CITY OF DUPONT

PLANNING DIVISION REPORT AND RECOMMENDATION TO THE DIRECTOR

Project: Type II Site Plan Review, Type I Short Plat, and Type I Design Review – Public Works Department Decant Facility

File Number: PLNG2019-025, -031, and -035

Irrigation Plan

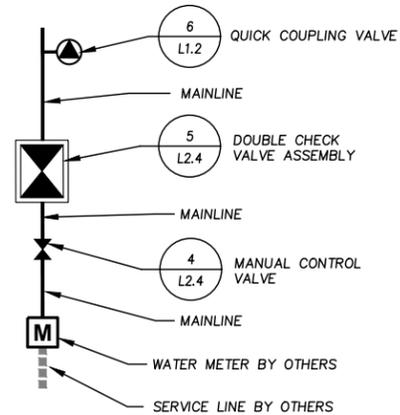
Staff Analysis and Conclusion: The Irrigation Plan Sheet LI.1 (Attachment I.10) does not provide water conservation measures or provide a projection of the amount of irrigation that will be required for the proposed landscape. The applicant shall provide water conservation measures and irrigation calculations showing compliance with DMC 25.90.040 at the time of site development permit. (Condition 4)

Planting Plan

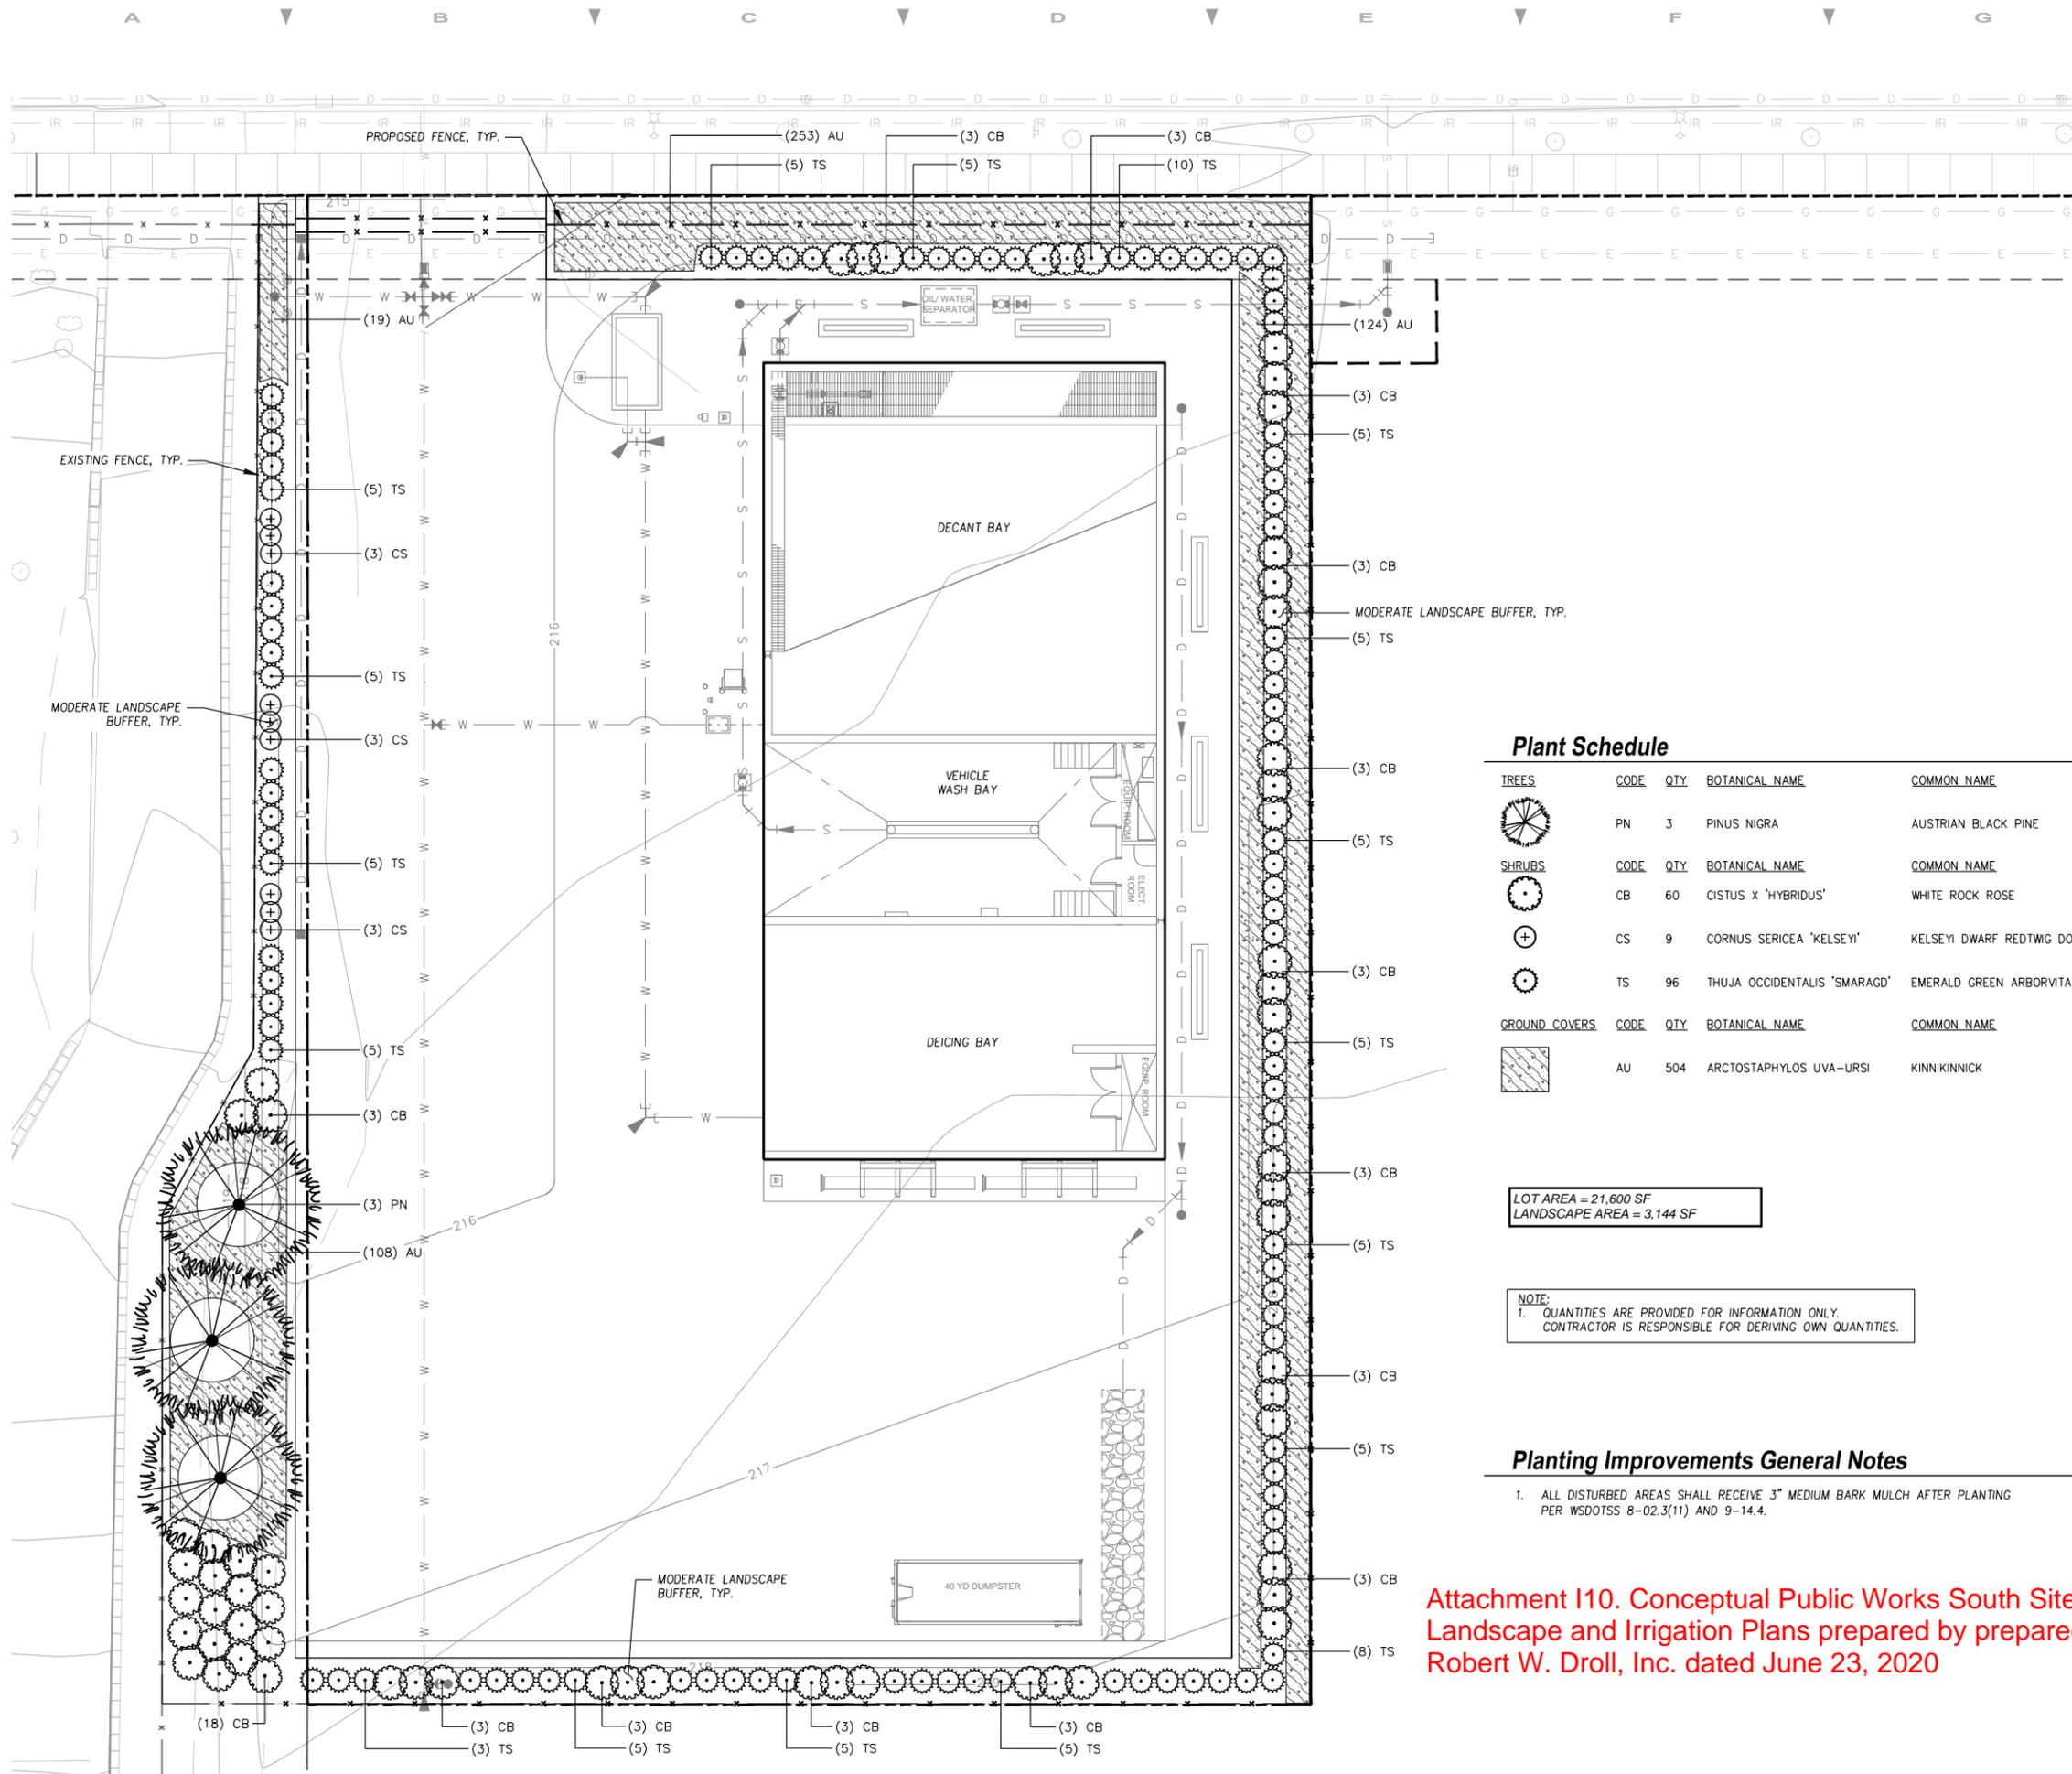
Staff Analysis and Conclusion: The Planting Plan Sheet L3.1 (Attachment I.10) indicates that proposal will provide 3,144 square feet (14%). The Topsoil Plan Sheet L2.1 (Attachment I.10) indicates that topsoil will be spread across the entire 4,800 square foot planting area (22%). City staff measured approximately 4,000 square feet of landscaping utilizing BlueBeam software. There is inconsistency in the landscaping plans showing compliance with DMC 25.90.020(2). As such, prior to issuance of site development permit the applicant shall provide a minimum of 20% landscaping area and correct all landscaping area calculation inconsistencies. (Condition 3.a)
